SUBJECT: DEPARTMENT OF THE ARMY PERMIT Number NAN-2012-00090-M1
Issued to New York State Thruway Authority on 25 April 2013
Authorizing Regulated Work to Facilitate Construction of The New NY
Bridge in the Hudson River Between Tarrytown and Nyack, New York

SUBJECT: DEPARTMENT OF THE ARMY PERMIT Number NAN-2012-00090-M1
Issued to New York State Thruway Authority on 25 April 2013
Authorizing Regulated Work to Facilitate Construction of The New NY
Bridge in the Hudson River Between Tarrytown and Nyack, New York

4. Based upon an evaluation of the administrative record supporting the issuance of the subject permit, a review of the permittee's submitted materials in support of their permit modification request [reference 1(b)], the subject permit is hereby modified so that:

TEMPORARY DOCKING FACILITY
AT HUDSON HARBOR
TAPPAN VILLAGE, WESTCHESTER COUNTY

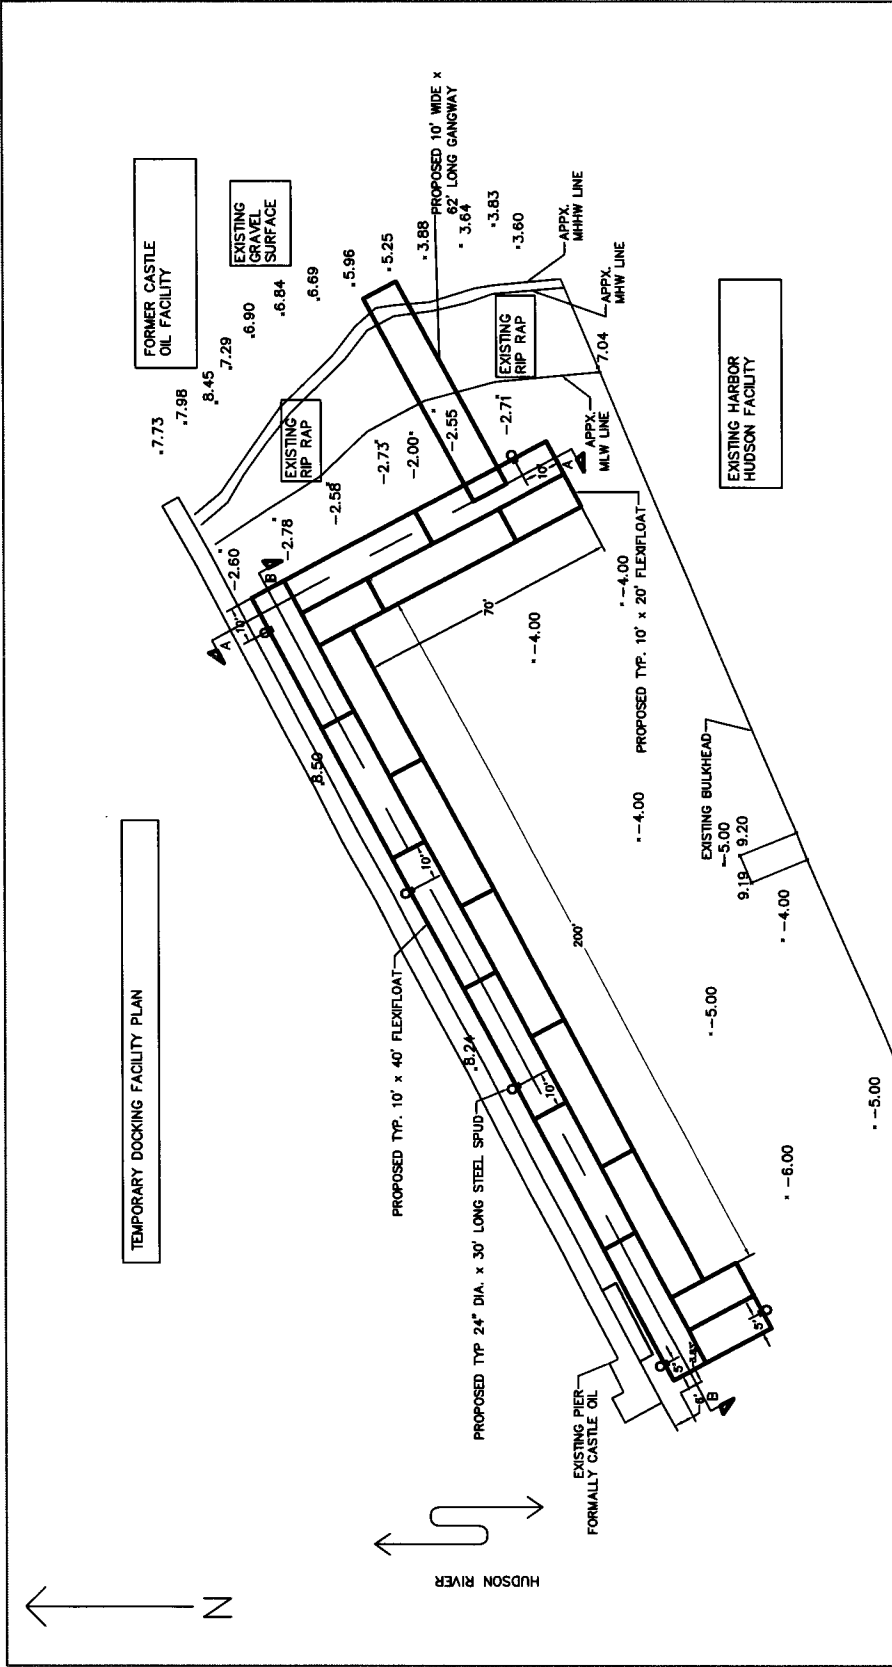
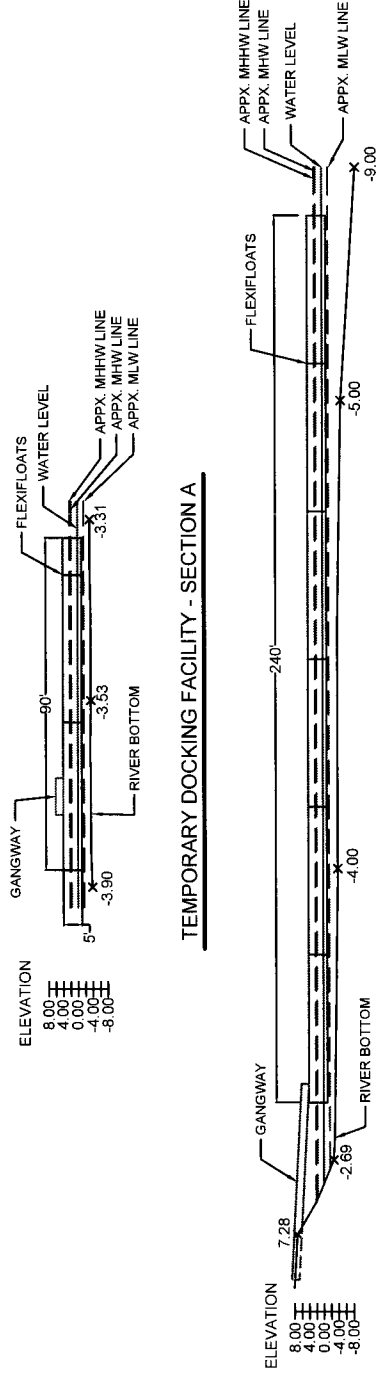
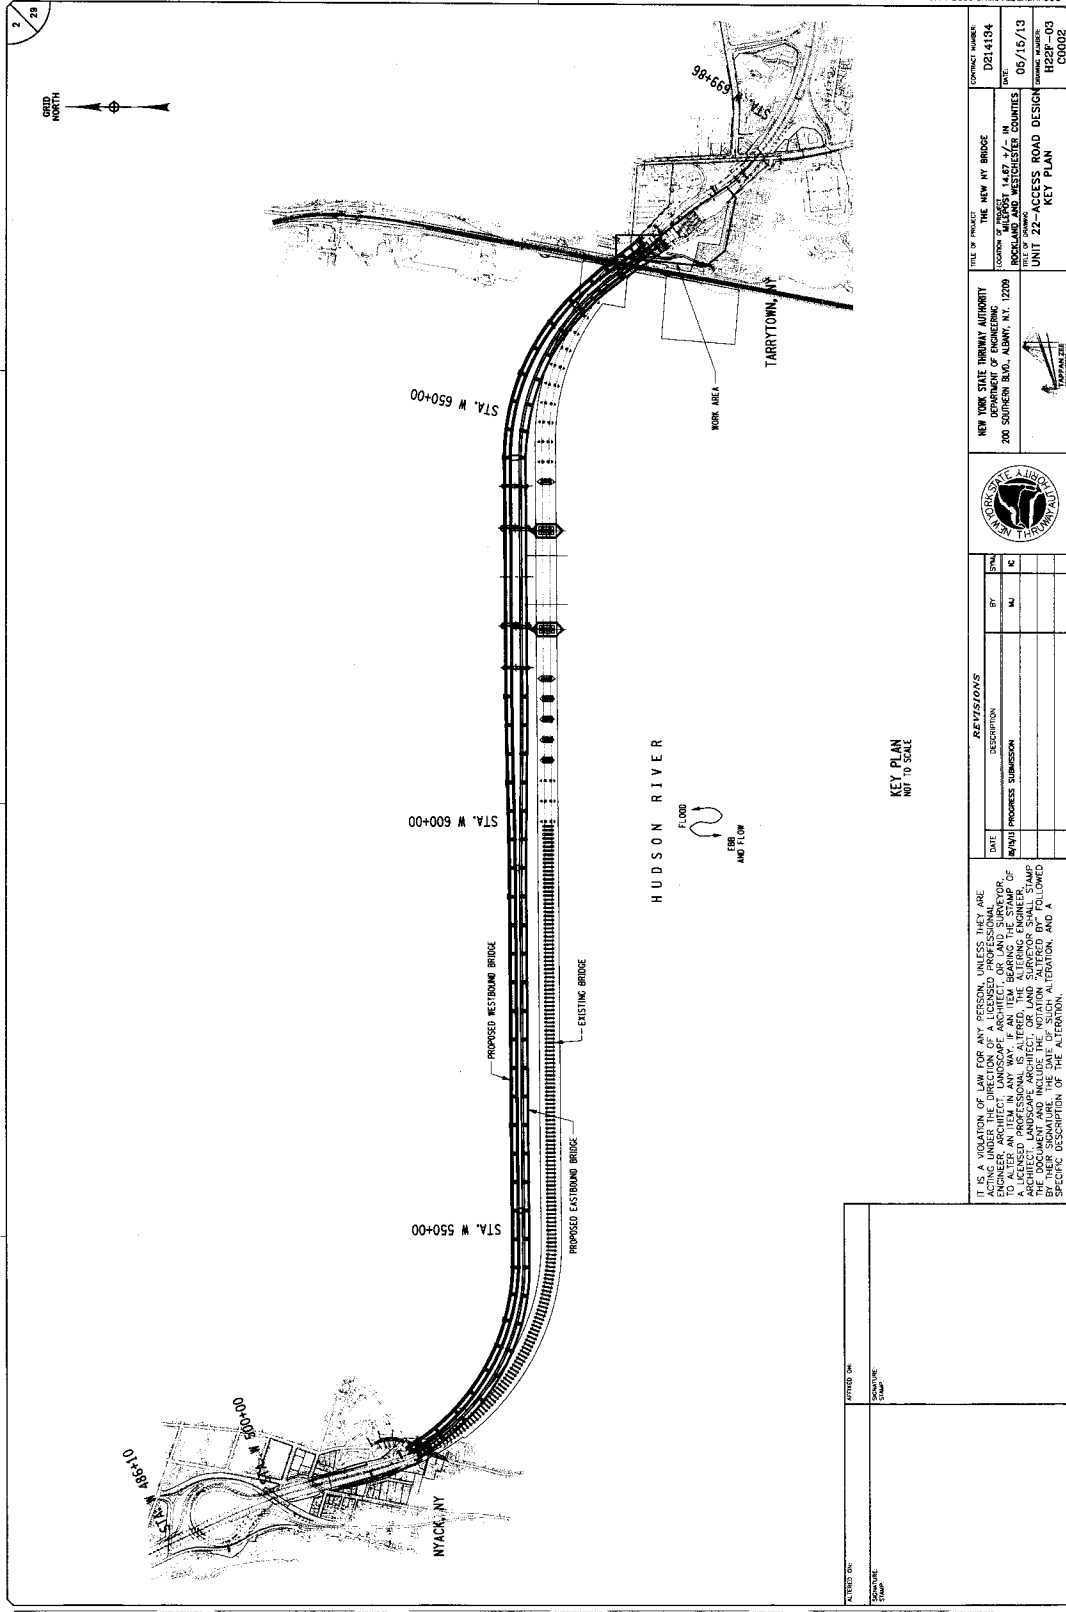
i. Three (3) permit drawings titled Location Map and Temporary Docking Facility dated today, 24 June 2013, are hereby added to the subject issued Department of the Army permit.

ACCESS ROAD - GENERAL LOCATION PLAN
SCALE: 1"=80'

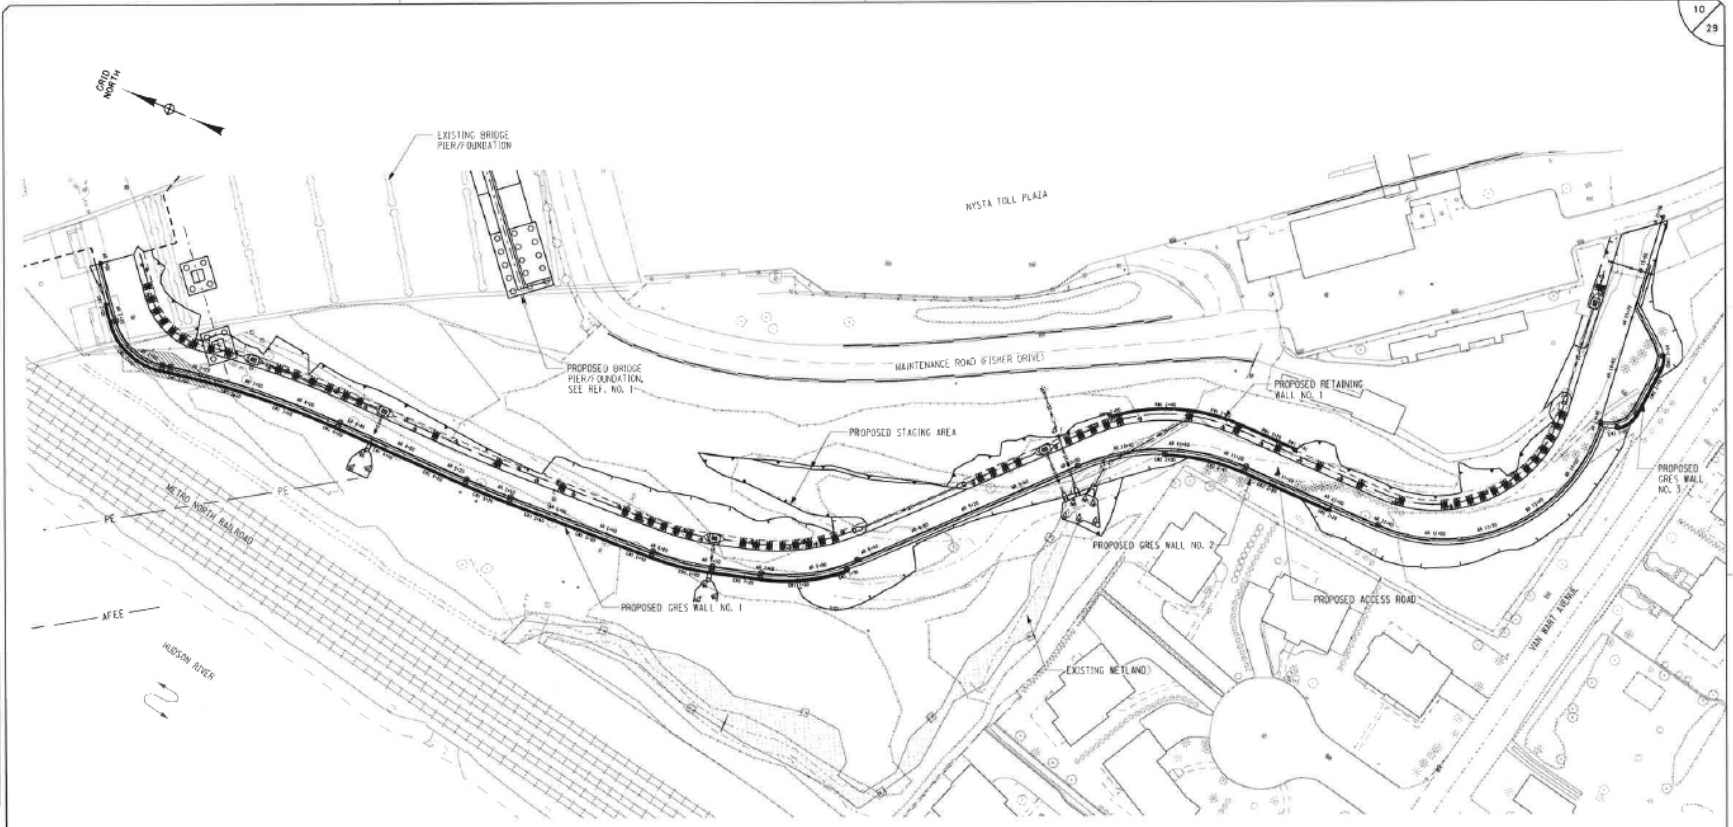
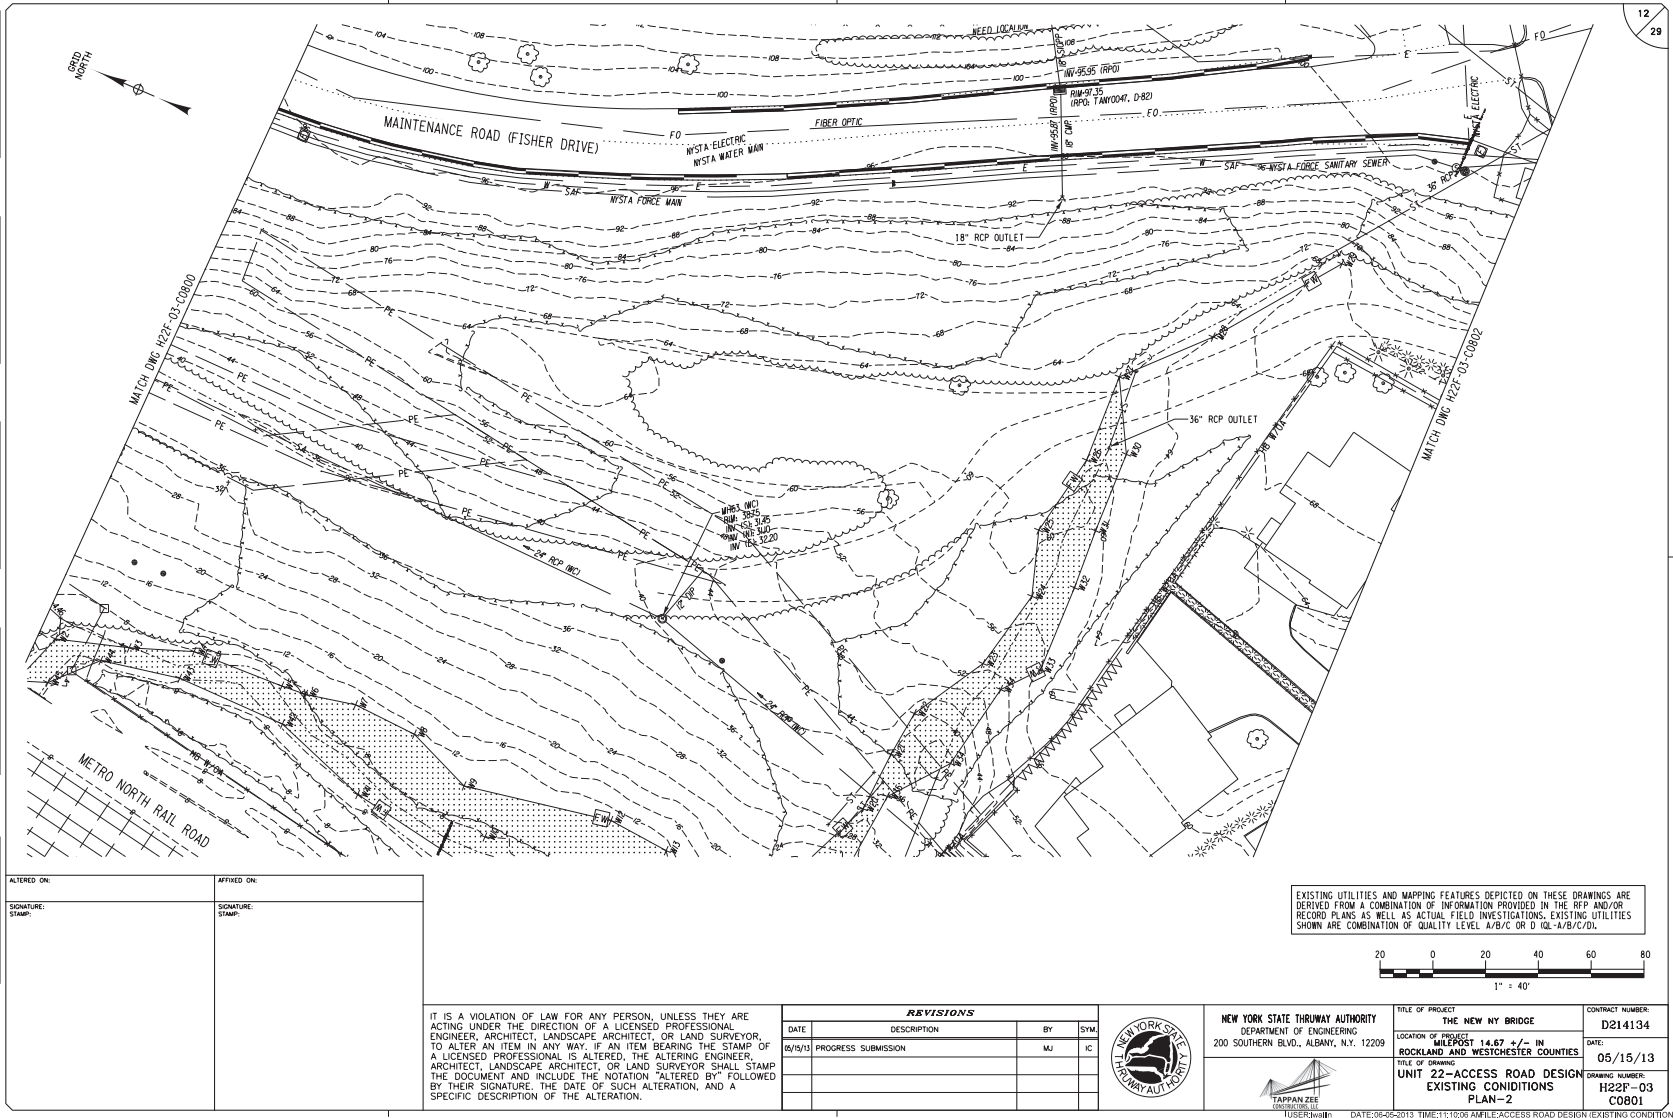
ii. Six (6) permit drawings titled Unit 22-Access Road Design dated today, 24 June 2013, are hereby added to the subject issued Department of the Army permit.

(M) The permittee shall mitigate at Piermont Marsh for the herein authorized filling of 900 Square Feet of the unnamed, non-navigable, intermittent stream and its associated wetlands.
